7-1– 12

504.5.1, 701.1.2 (NEW), 703.2.1.1 (New), 703.2.1.2 (New), 703.5.3.1 (New), 703.5.3.2 (New), 703.6.3.1 (New), 703.6.3.2 (New), 705.3

Proposed Change as Submitted

Proponent: Sharon Toji, Access Communication, representing self

7-6– 12**Table 703.2.4, Table 703.7.4*****Proposed Change as Submitted***

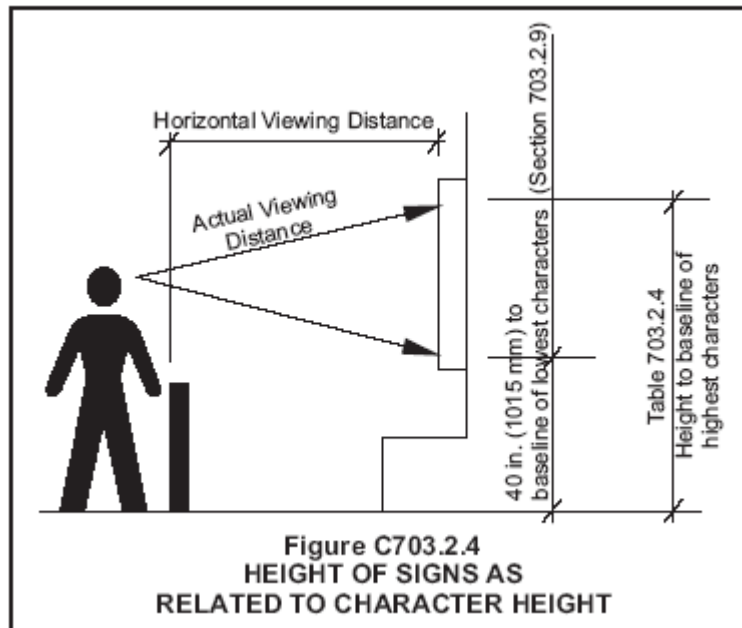
(Table 703.2.4) This proposal will clarify how the provisions are to be applied. Primarily the major revision needed is shown in footnote 1 of the table. If the committee desired, this footnote could be removed and the heading of the first column could be revised to read "Height above floor to baseline of characters on the highest line". Section 703.2.9 states that the minimum 40 inch height is "measured to the baseline of the character." That is acceptable since it is a minimum height requirement. That text does not however explain whether the ranges in the table (40 to 70, 70 to 120, or >120) is for the highest, lowest, average or each individual line of text. Therefore footnote 1 will clarify how the measurement is to be made and completes the information that is needed to comply with Section 703.2.9 which indicates "Heights shall comply with Table 703.2.4, based on the size of the characters on the sign". (Section 703.2.9 measures the minimum height to the lowest line of characters while Table 703.2.4 is measuring to the highest line of information when determining the minimum character heights.)

The second footnote is not as important since Section 703.2.4 clearly describes how the horizontal distance is to be measured. However, if footnote 1 is added to address the vertical distance then footnote 2 should be included for the clarity.

The following figure from the A117.1 commentary will help explain the intent of the change. It should also be noted that the commentary explaining Table 703.2.4 indicates the vertical height measurement to be used for determining the character height is taken "to the baseline of the highest line of the characters."

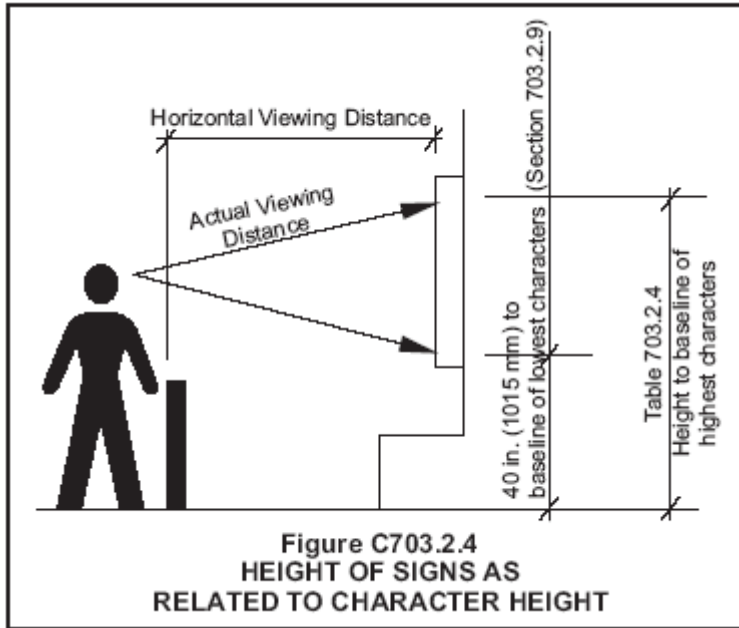
(Table 703.7.4) This proposal will clarify how the provisions are to be applied. Primarily the major revision needed is shown in footnote 1 of the table. If the committee desired, this footnote could be removed and the heading of the first column could be revised to read "Height above floor to baseline of characters on the highest line". Section 703.7.9 states that the minimum 40 inch height is "measured to the baseline of the character." That is acceptable since it is a minimum height requirement. That text does not however explain whether the ranges in the table (40 to 70, 70 to 120, or >120) is for the highest, lowest, average or each individual line of text. Therefore footnote 1 will clarify how the measurement is to be made and completes the information that is needed to comply with Section 703.7.9 which indicates "Heights of low resolution variable message signs characters shall comply with Table 703.7.4, based on the size of the characters on the sign". (Section 703.7.9 measures the minimum height to the lowest line of characters while Table 703.2.4 is measuring to the highest line of information when determining the minimum character heights.)

The second footnote is not as important since Section 703.7.4 clearly describes how the horizontal distance is to be measured. However, if footnote 1 is added to address the vertical distance then footnote 2 should be included for the clarity.

The following figure from the A117.1 commentary will help explain the intent of the change. It should also be noted that the commentary explaining Table 703.2.4 indicates the vertical height measurement to be used for determining the character height is taken "to the baseline of the highest line of the characters."
